**METROPOLITAN GOVERNMENT OF NASHVILLE AND DAVIDSON COUNTY**

**STAFF RECOMMENDATION**  
**814 Petway Avenue**  
**March 19, 2014**

**Application:** New construction - infill  
**District:** Greenwood Neighborhood Conservation Zoning Overlay  
**Council District:** 06  
**Map and Parcel Number:** 0820432000  
**Applicant:** Brandon Vance, Design Build East  
**Project Lead:** Paul Hoffman, paul.hoffman@nashville.gov

<p><b>Description of Project:</b> The applicant proposes to build a new one-and-a-half story house on the existing first-story framework of a non-contributing house.</p> <p><b>Recommendation Summary:</b> Staff recommends approval of the infill construction at 814 Petway Avenue with the conditions that:</p> <ul style="list-style-type: none"> <li>• staff provides final review of windows, doors, shutters, porch materials, color of roofing material and location of utilities;</li> <li>• the existing driveway be fully removed; and,</li> <li>• a new parking area may be approved by staff at the rear of the property.</li> </ul> <p>With these conditions, Staff finds that the project meets section II.B of the <i>Greenwood Neighborhood Conservation Zoning Overlay Handbook and Des

**Figure 3. Existing curb cut and driveway**

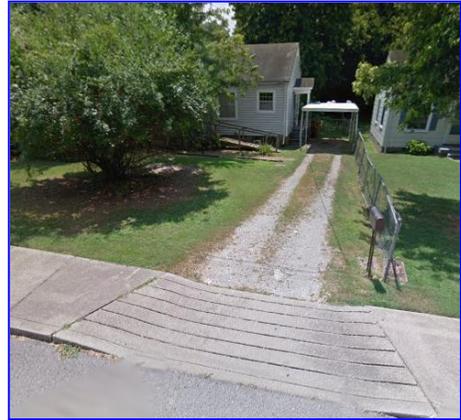
Orientation: There will be no change to the orientation of the house, which will address Petway as the current house does, although with a larger and deeper porch. Currently there is a driveway to the right of the house that continues past the house. The applicants propose to truncate this driveway because they are extending the width of the house and there is no longer room to carry the driveway past the house. The result is a front yard parking pad, which is not appropriate in the historic districts. There is no rear alley but the lot is a corner lot with an opportunity for a driveway or parking area at the rear of the home accessed from McFerrin. The closest house on McFerrin also has a driveway. Staff recommends that the existing driveway be fully removed and that a new parking area be approved by staff at the rear of the property. The proposal also includes a concrete walkway, which does meet the design guidelines as it helps to orient the building to the street. With the condition that the front yard driveway is removed, the project meets section II.B.1.f.

Appurtenances & Utilities: The location of HVAC and other utilities was not noted. Staff asks that the HVAC be located on the rear façade, or on a side façade beyond the midpoint of the house and that the front yard parking pad be removed from the plans. No additional site improvements are proposed. With these conditions, the project meets section II.B.1.i.

- staff provides final review of windows, doors, shutters, porch materials, color of roofing material and location of utilities;
- the existing driveway be fully removed; and,
- a new parking area may be approved by staff at the rear of the property.

FRONT ELEVATION  
1/8" = 1'-0"

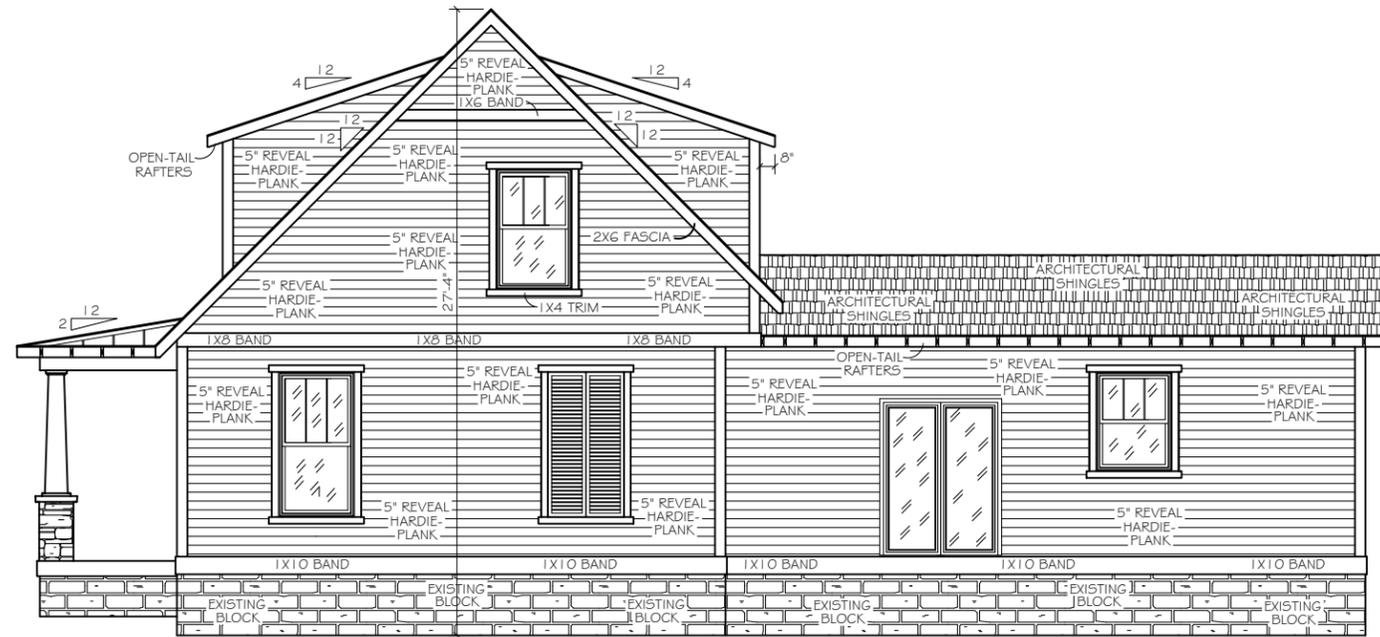
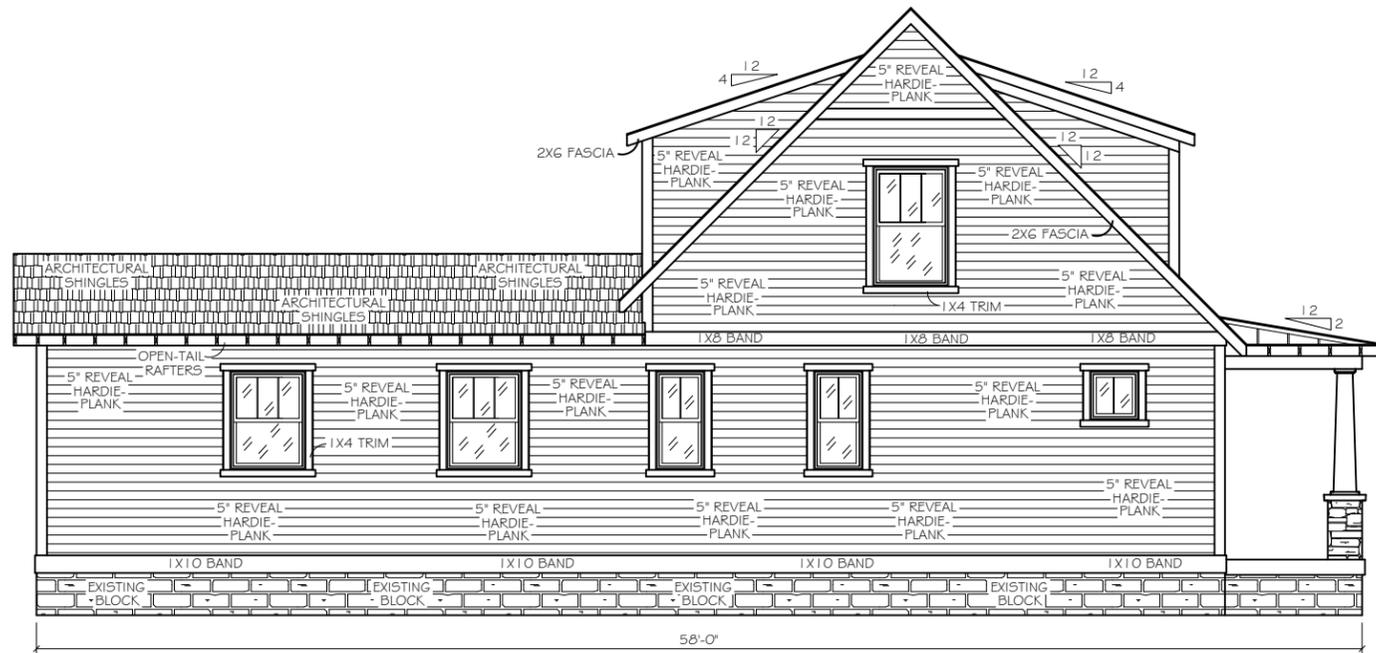
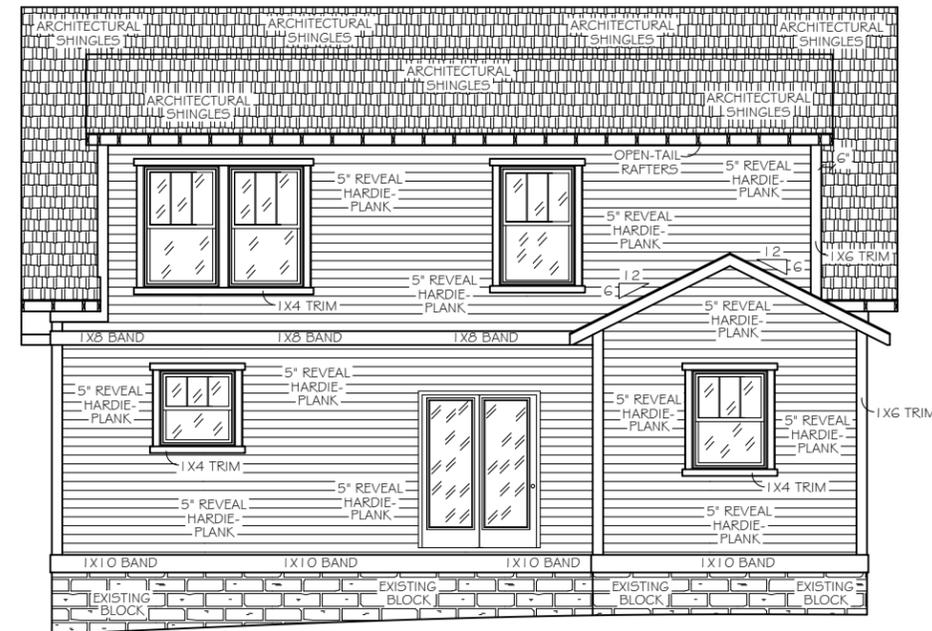
Height & Scale: The proposed house is one and a half stories and will be twenty-six feet (26') tall from grade. The height range in the vicinity is from eighteen to thirty-one feet (18'-31'); the overall height of the new construction is appropriate to the context. It will be built on the existing foundation and first floor framing. The existing foundation has a height ranging from one foot six inches to three feet (1'6" to 3'). Its eaves will be ten feet (10') from the first floor. The width of the house will be thirty-five feet eight inches (35'8"), adding three feet eight inches (3'8") to the width of the existing house. The houses nearby range in width from thirty to forty feet (30-40'). Staff finds the massing, height and scale of the proposed infill to meet sections II.B.1.a. and b.

Materials: The new structure will be clad in smooth-face cement fiberboard with a five inch (5") reveal. The trim will be wood. The existing concrete block foundation will remain. The roof will be architectural shingles, and the front porch will have a metal roof. The roof colors were not indicated. The porch floor is concrete; however materials for the porch steps and columns were not specified. The windows, doors and shutters were also not specified; staff asks to approve these materials. A driveway and walkway will be concrete. With staff's final approval of the material of porch columns and steps, the color of roofing materials, and window, doors and shutters prior to purchase and installation, staff finds that the known materials meet section II.B.1.d.

Roof form: The side-gabled roof has a pitch of 12/12, and the rear ell is 6/12. Its shed dormers will have a 4/12 pitch. The roof will be compatible with the context and the project meets section II.B.1.e for roof shape.

Proportion and Rhythm of Openings: The windows on the infill are all generally twice as tall as they are wide, thereby meeting the historic proportions of openings. The longest expanse without an opening is nine feet (9') so there are no large expanses of wall space without a window or door opening. With this condition, staff finds the project's proportion and rhythm of openings to meet Section II.B.1.g.

814  
PETWAY

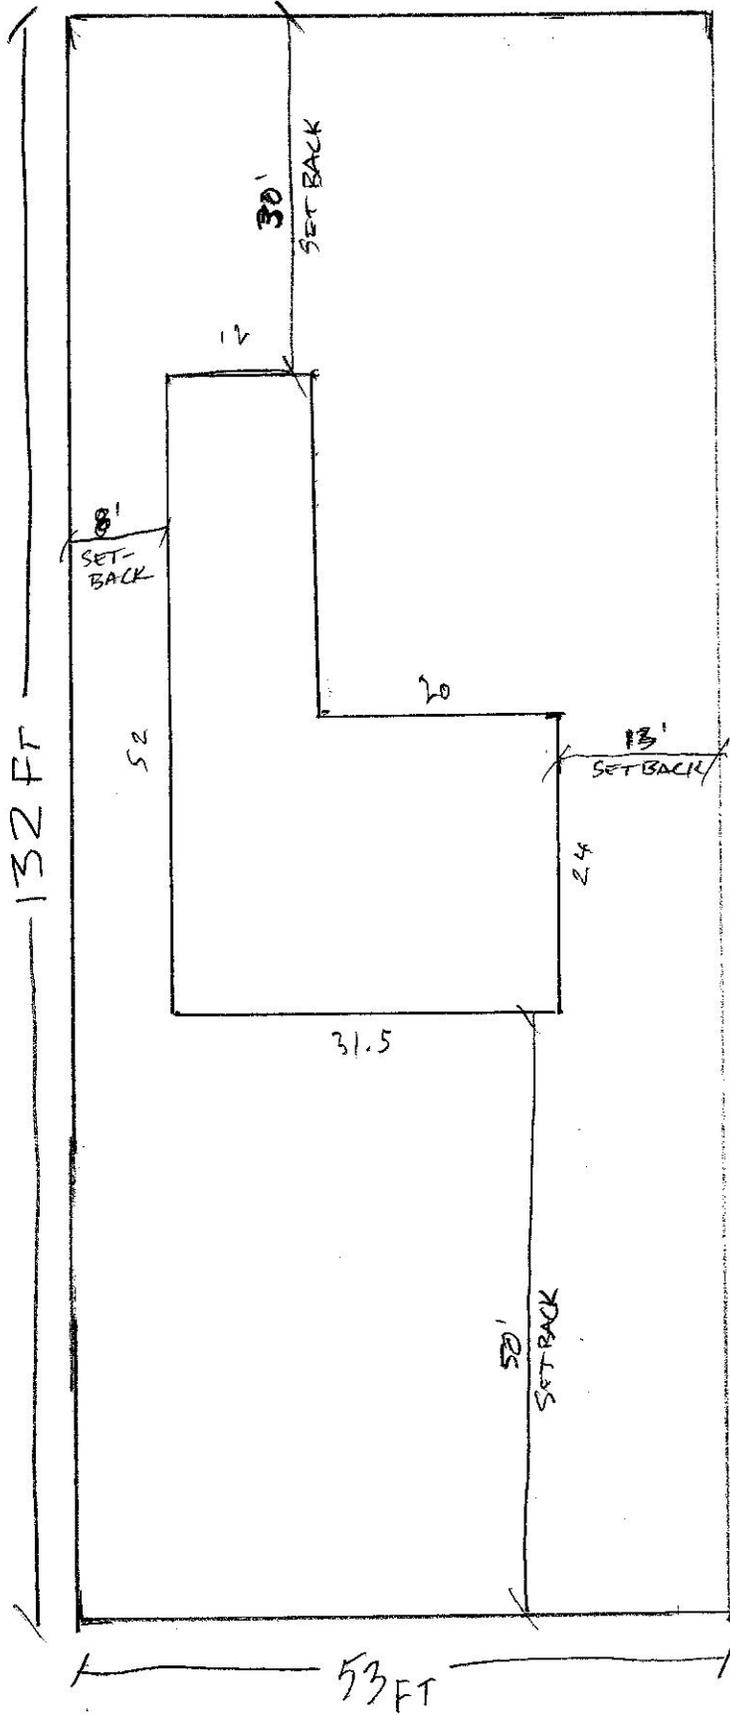
Setback & Rhythm of Spacing: The new house will be built on the foundation and first-floor framing of the existing house. There will be a slight change to the front setback, with the increase of depth of the front porch from four feet (4') to six feet (6'). The design guidelines request a minimum of a six foot (6') deep porch in order to have a usable porch so staff found the increase to be appropriate. Other buildings in the block-face are slightly closer to the street than this non-contributing so the new setback

is also found to be appropriate. Side setbacks will be ten feet (10') and eight feet (8'), and its rear setback will be thirty feet (30'), all of which meet bulk zoning setback requirements. The project meets section II.B.1.c.
